**DOCUMENT 00 90 00  
ADDENDUM**

**ADDENDUM NO. [4]                      Date: November 21, 2018**

**RE:                      GLENWOOD COMMUNITY SCHOOL DISTRICT  
ATHLETIC COMPLEX IMPROVEMENTS BID PACKAGE 2 REBID  
400 SIVERS ROAD  
GLENWOOD, IOWA 51534  
HSR PROJECT NO. 18005**

**FROM:                  HSR Associates, Inc  
100 Milwaukee Street  
La Crosse, WI 54603  
(608) 784-1830**

NOT TO SCALE

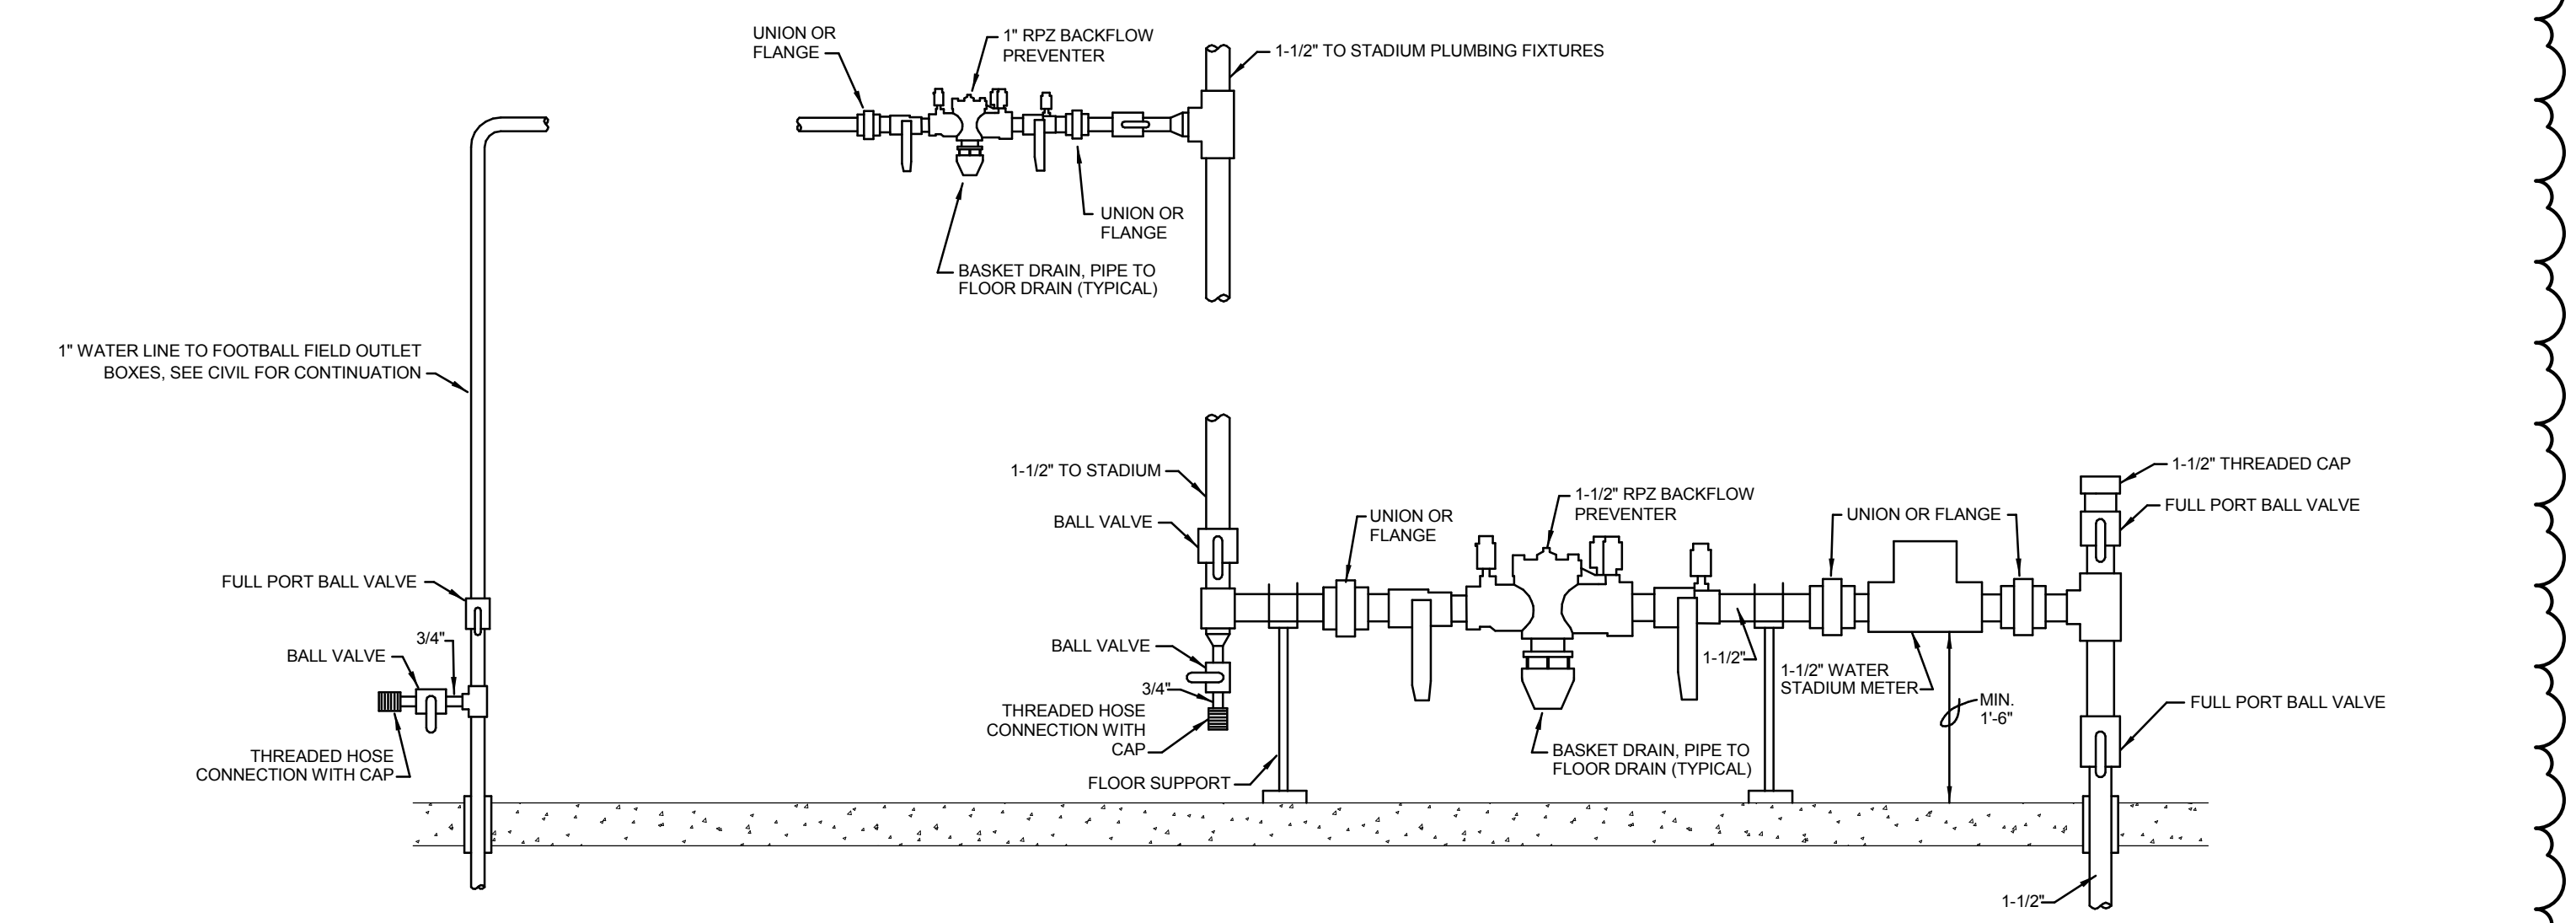
Sheet P102R STADIUM BUILDING PLUMBING PLAN 30 x 42 attached hereto.

- a. Revisions clouded on Drawing
  - b. Added elevator sump pump (SP-1) horizontal pipe discharge from 2" to 3" and extend to over to service sink (SS-1) in Jan. /Mech. B103.

- c. Locate domestic water heater (DWH-2) located on floor next to service sink.
  - d. Revised Stadium Water Service Detail – there are two details with (1) for Base Bid and (1) for Alternate Bid.

- e. Revised sheet note #7.
4. Sheet P103R PLUMBING SCHEDULES, DETAILS & SYMBOLS 30 x 42 attached hereto.
- a. Revisions clouded on Drawing
  - b. Update Elevator Pit Sump Pump Detail – Show 3" PVC horizontal pipe with 2" riser from sump pump (SP-1).

**P104R**

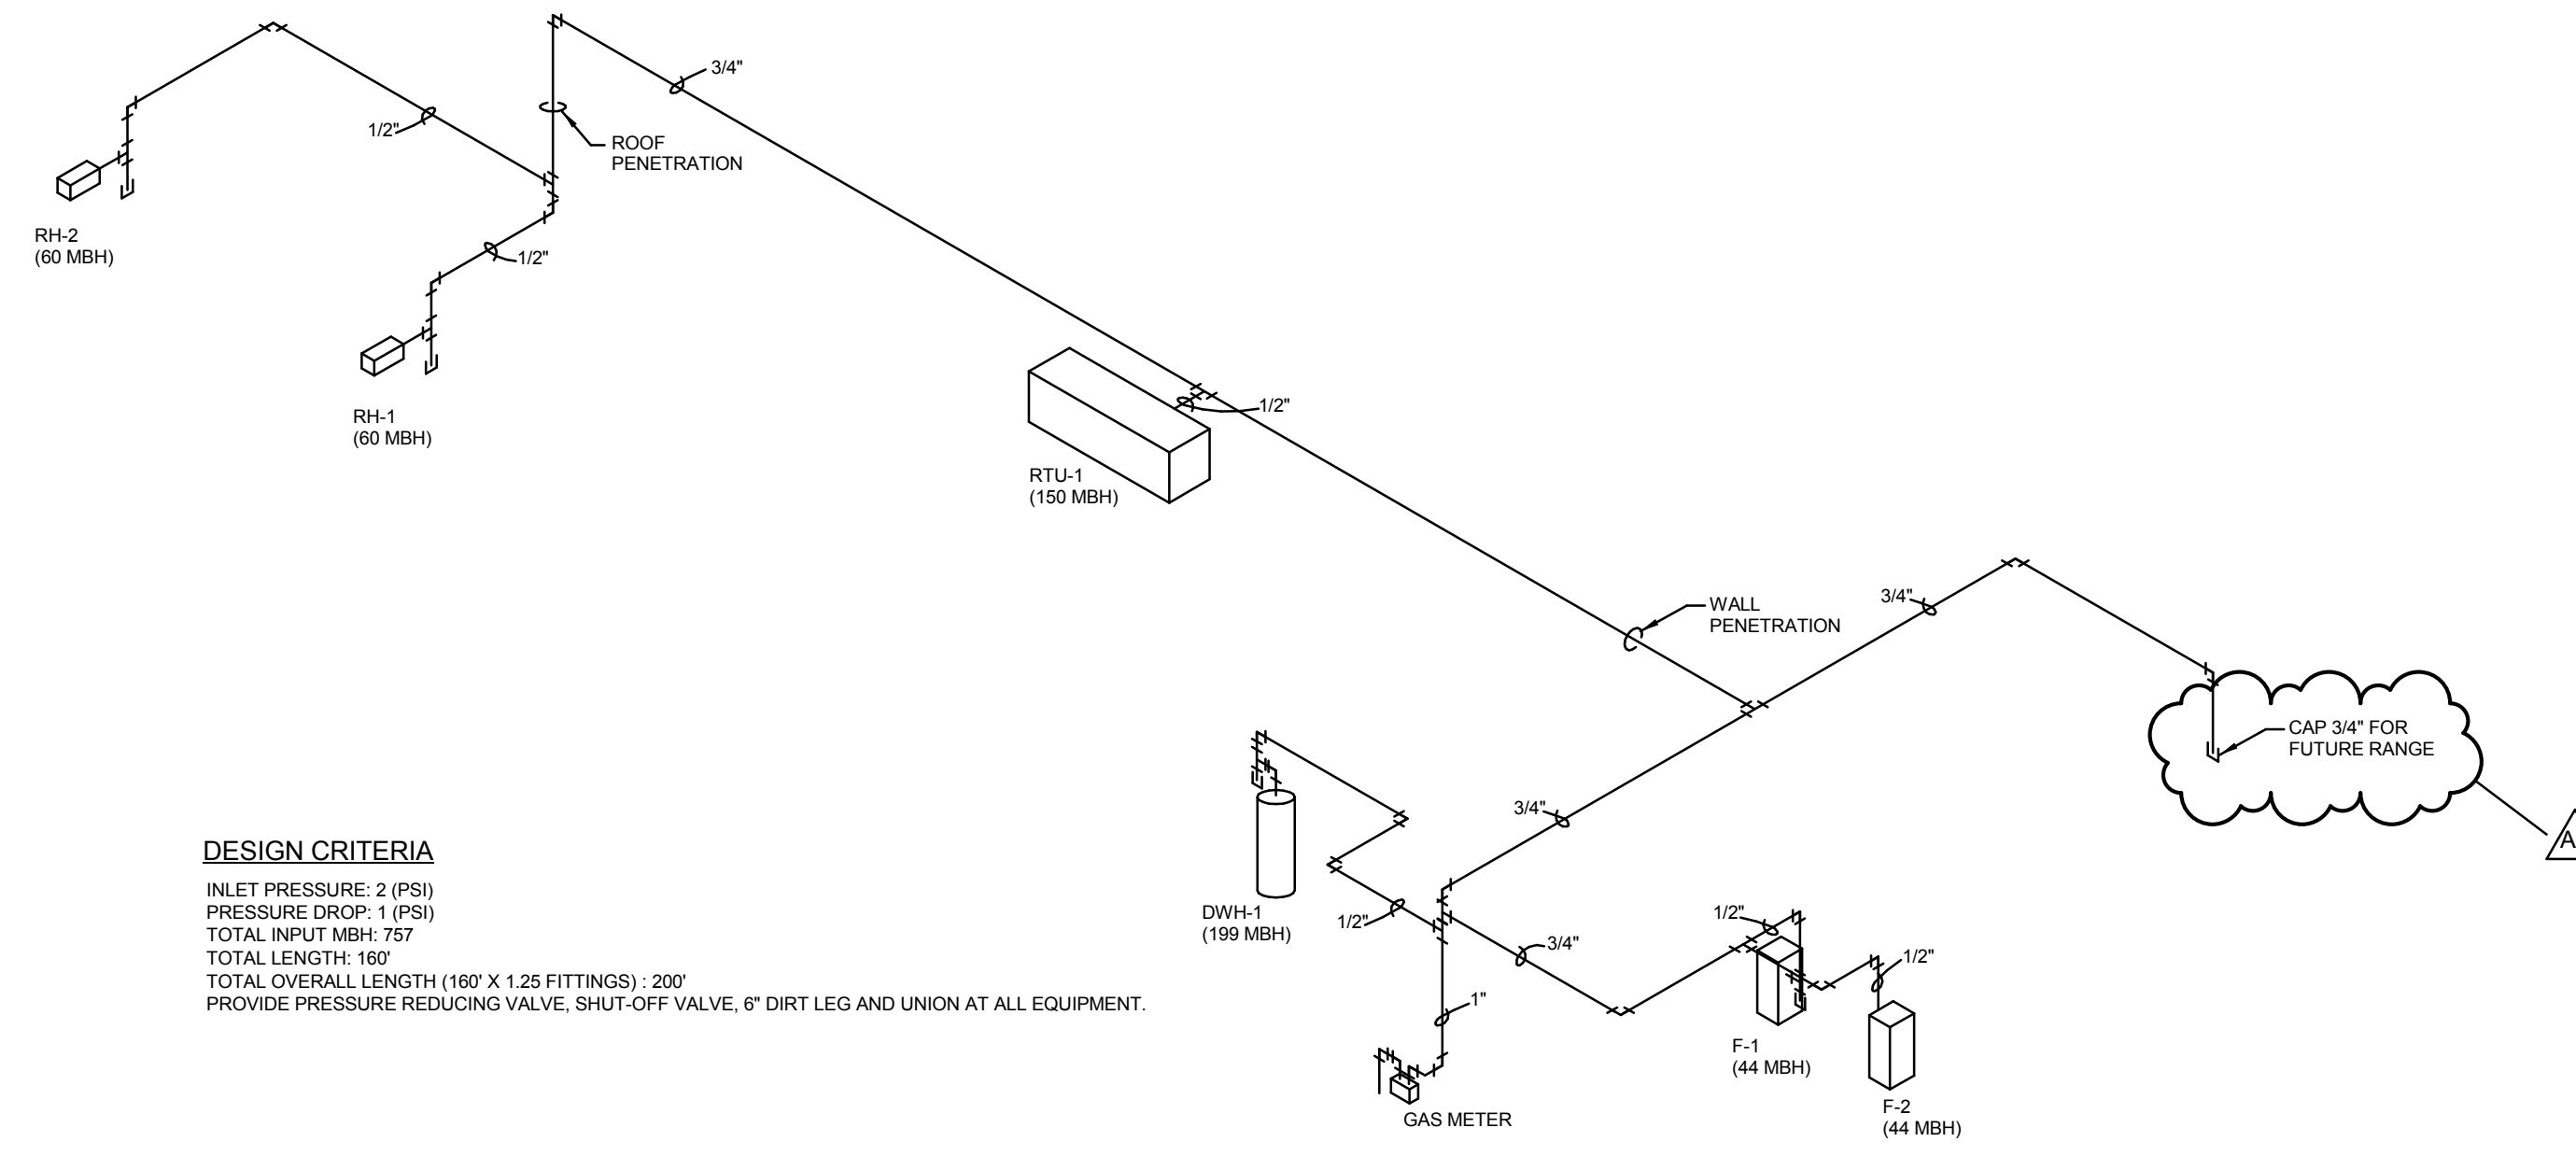
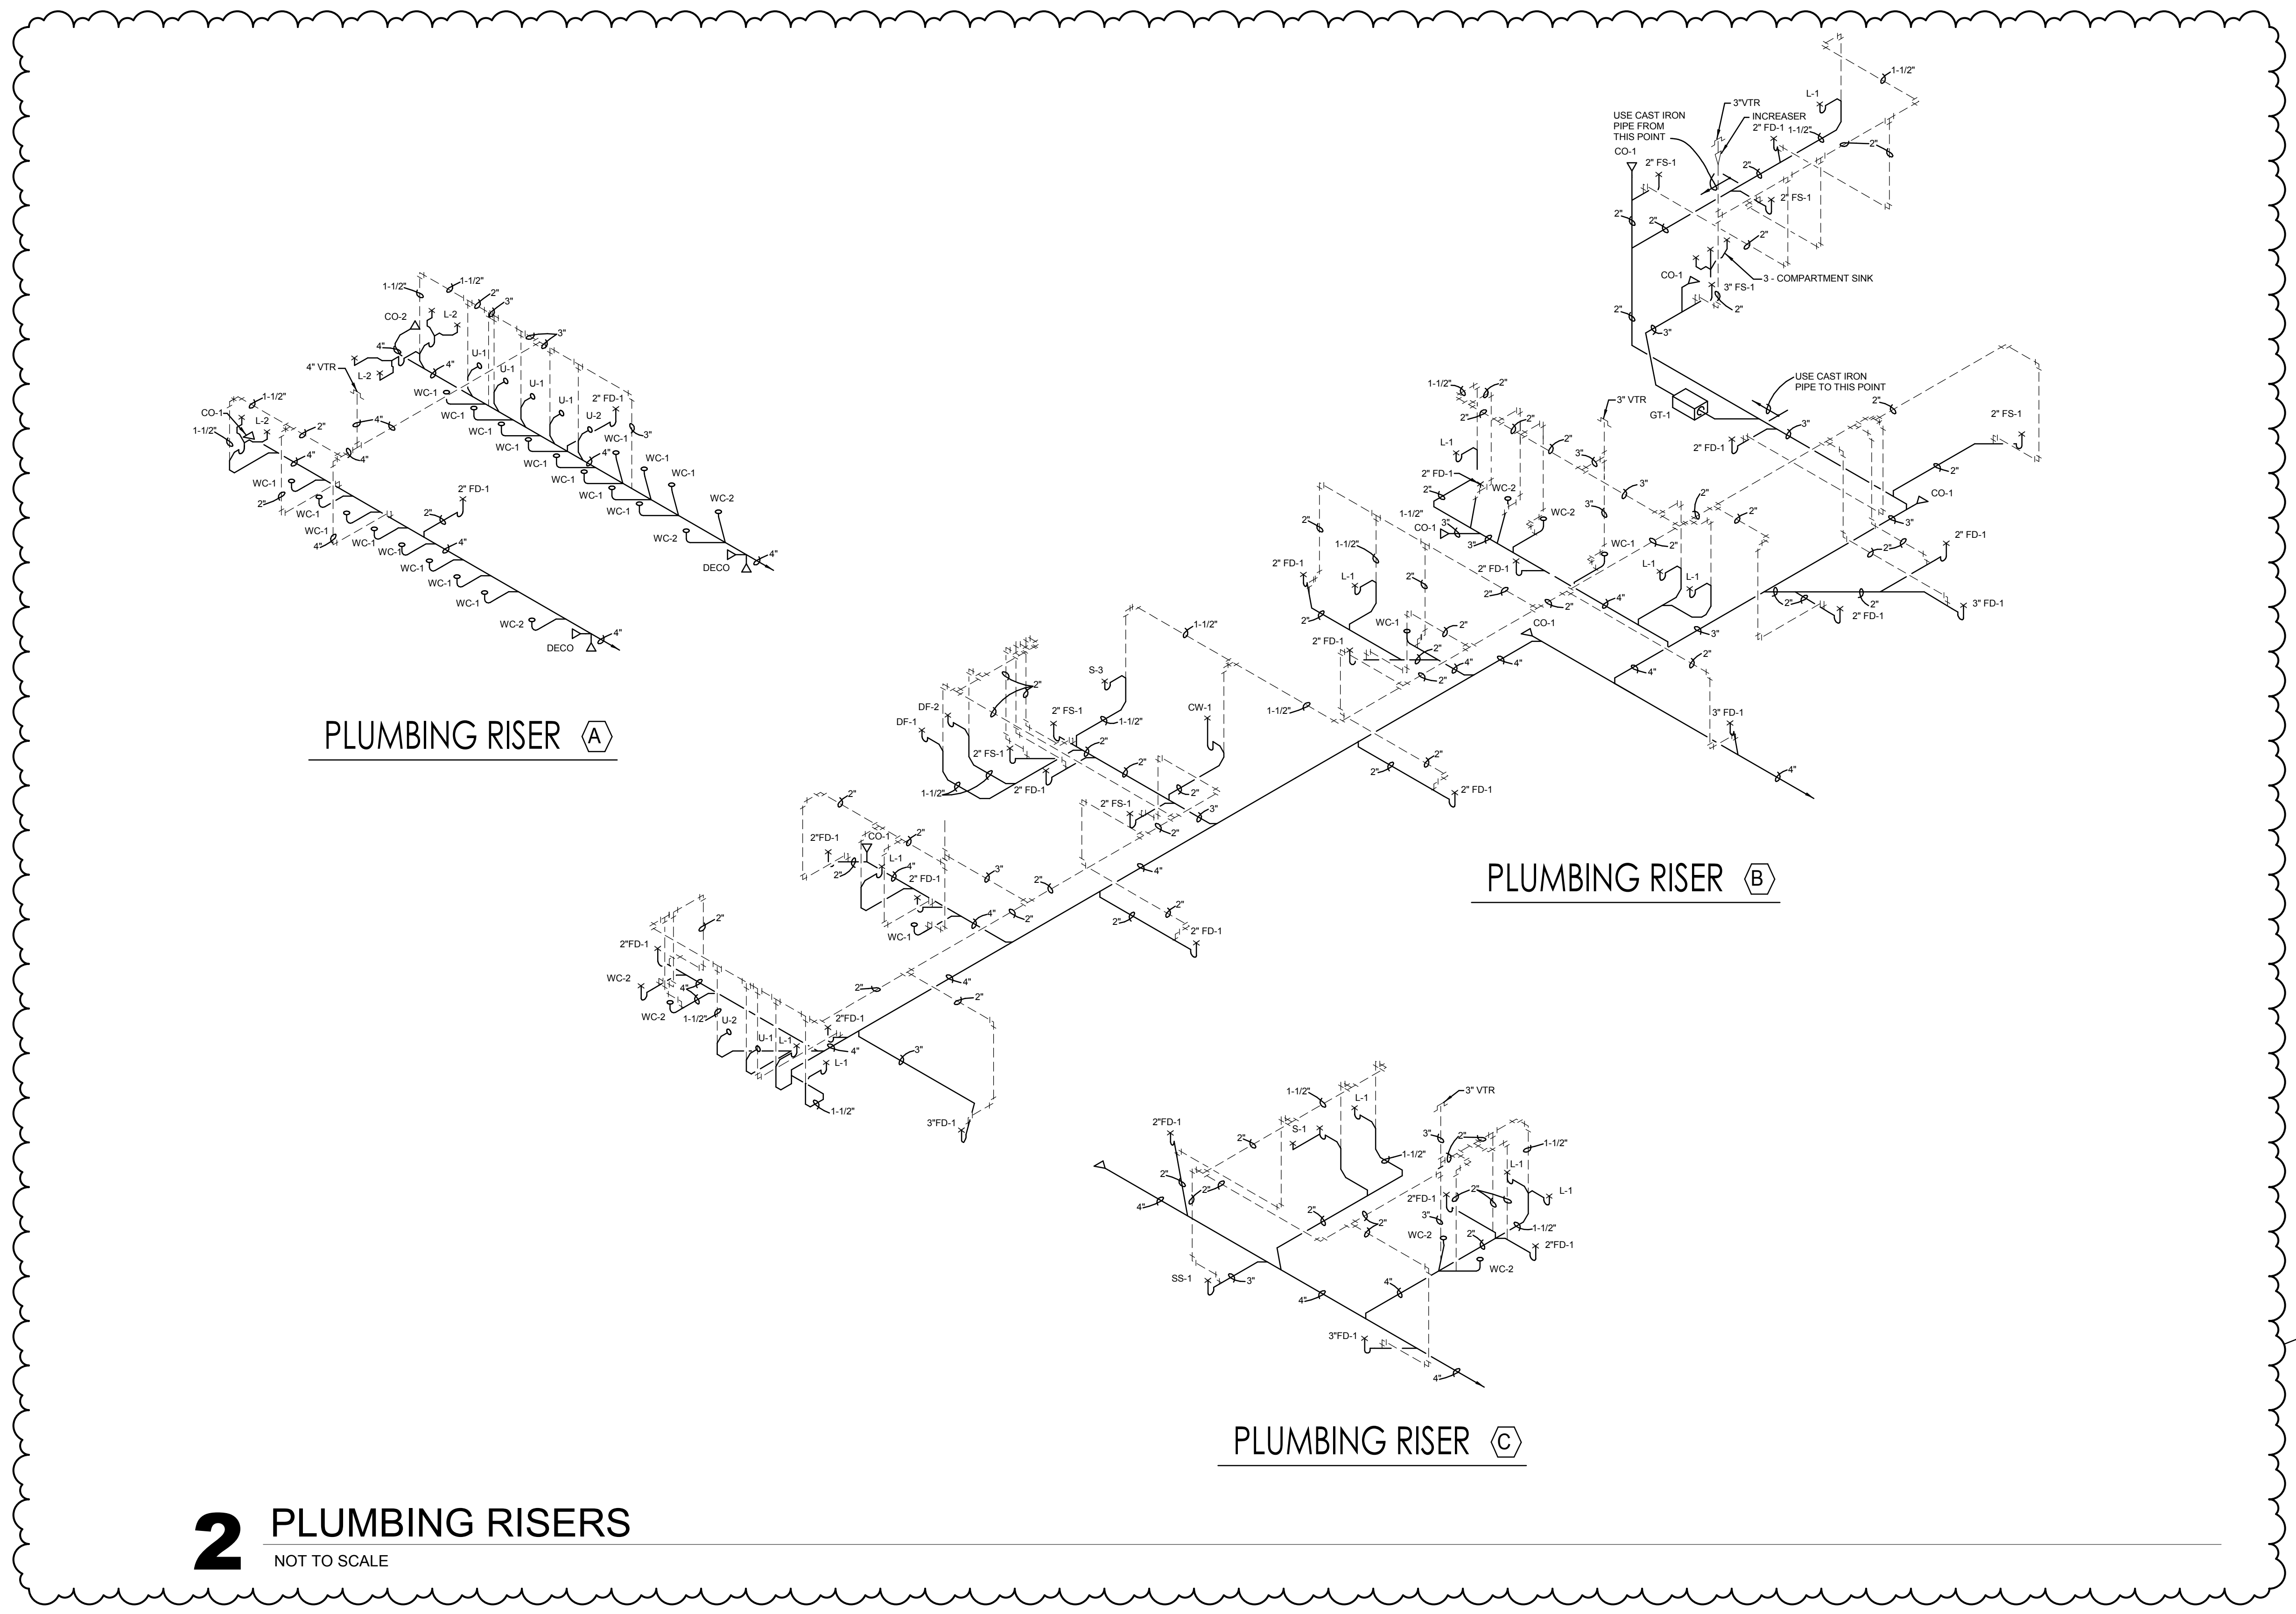
5. Sheet P104R PLUMBING & GAS RISERS 30 x 42 attached hereto.
- a. Revisions clouded on Drawing
  - b. Gas Riser – Shows 3/4" gas pipe capped for future range.
